FPL Energy
Seabrook Station

Seabrook Station
Facility Operating License NPF-86
Supplemental Response to Request for Additional Information Regarding
License Amendment Request 04-03, Application for Stretch Power Uprate

Enclosure 1 to Letter SBK-L-05054
Supplemental Information to NRC
Regarding Seabrook Station LAR 04-03
Application for Stretch Power Uprate

INADVERTENT EMERGENCY CORE COOLING SYSTEM INITIATION AT POWER EVENT EVALUATION

Enclosure 3 to Letter SBK-L-05054
Interim Evaluation
Inadvertent ECCS Initiation at Power Graphs

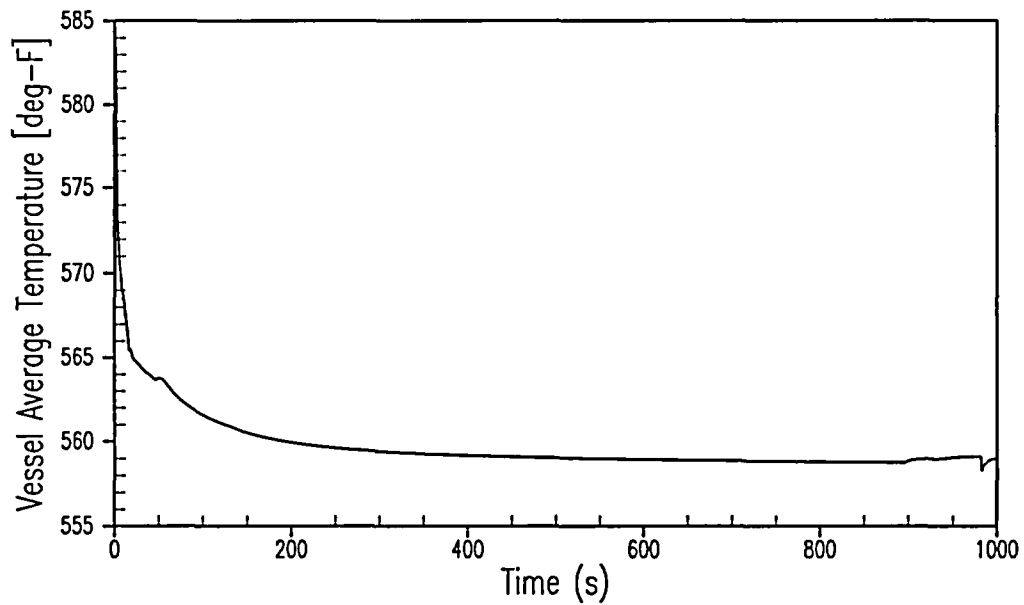
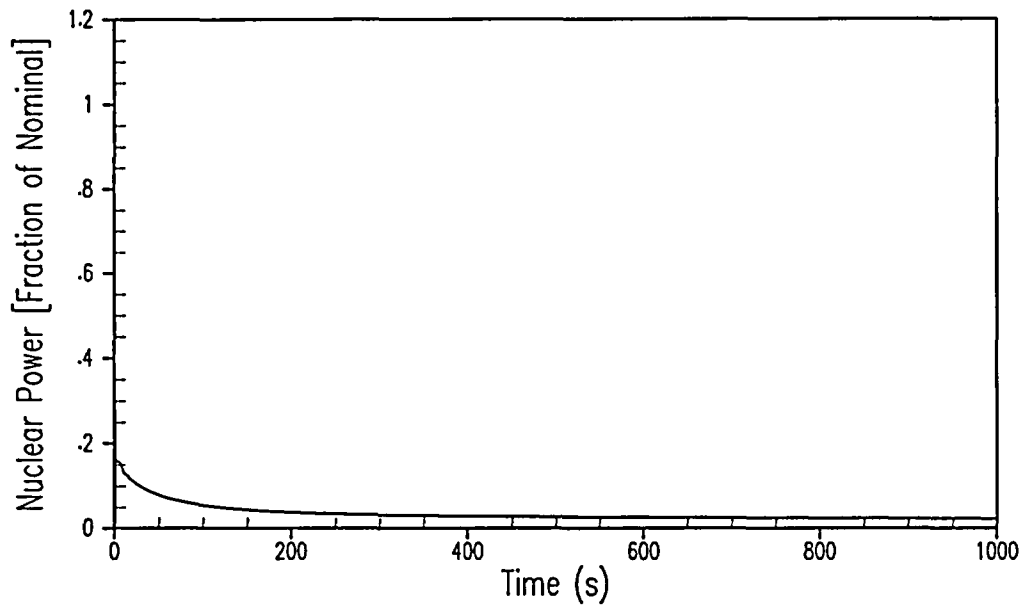
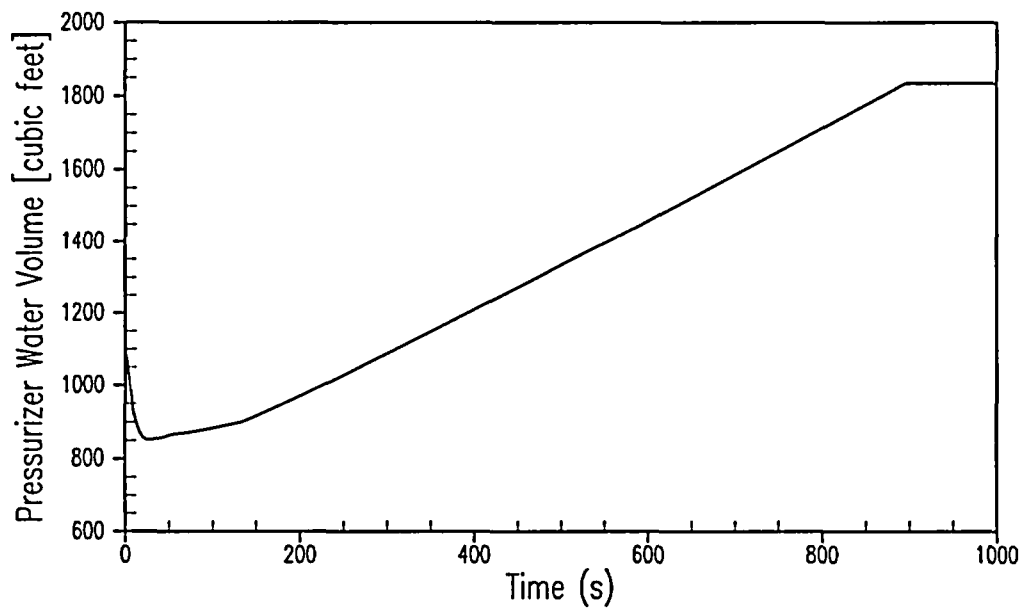
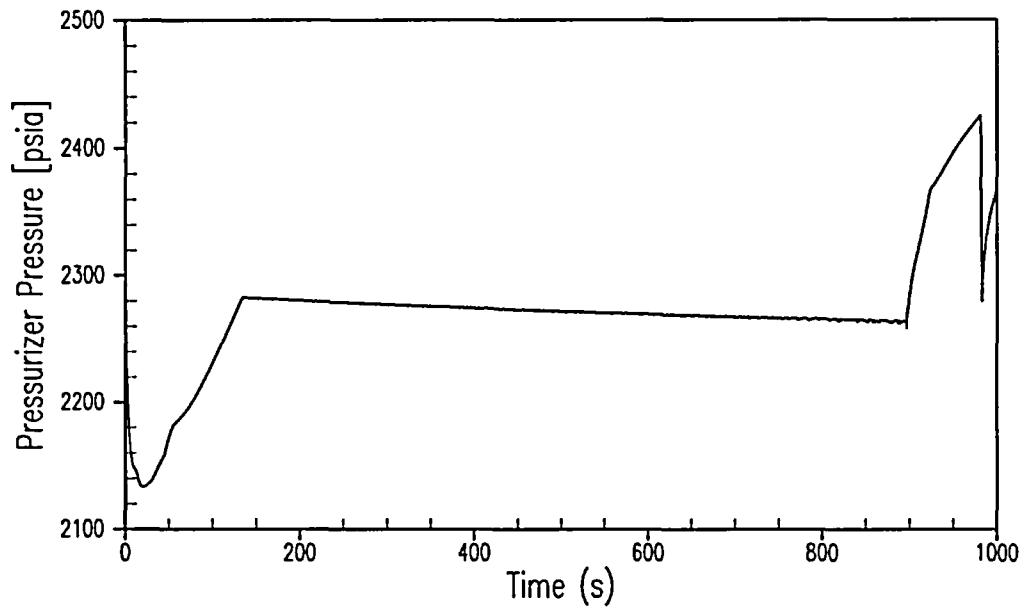
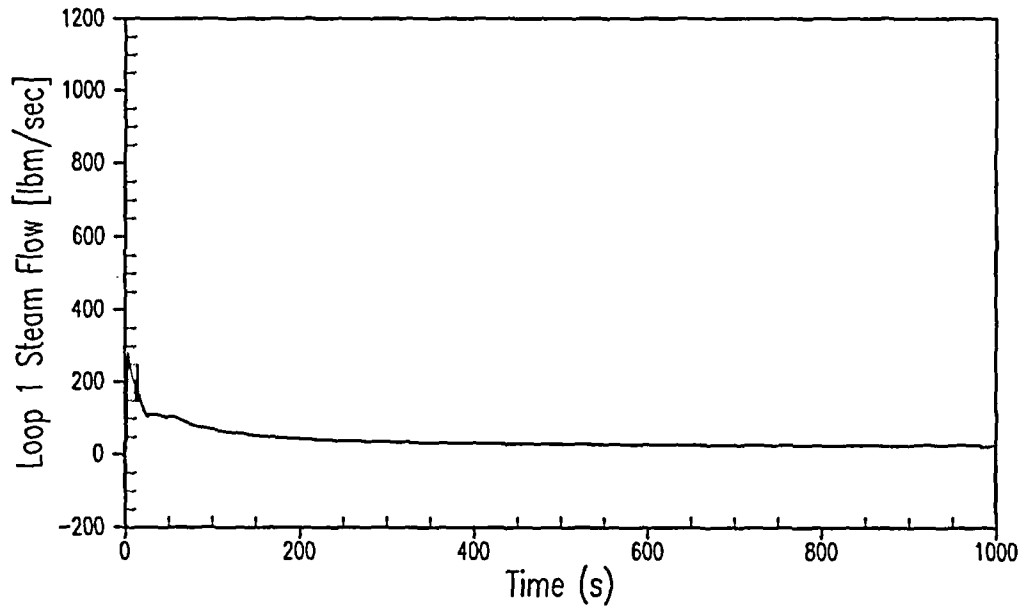
FPL Energy Seabrook has evaluated the NRC concern that for the inadvertent ECCS initiation at power event, the pressurizer will become water solid prior to 10.1 minutes which is the time required for the operator to isolate the high head ECCS injection flowpath.

- The time for the pressurizer to become water solid is 14.9 minutes which is longer than the 10.1 minutes required for the operator to isolate the high head ECCS injection flowpath.
- As a result, neither the pressurizer power-operated relief valves nor the pressurizer safety valves are challenged to relieve water within 10.1 minutes following an inadvertent ECCS initiation at power event.

Graphs of plant parameters associated with this evaluation are provided in Enclosure 3.
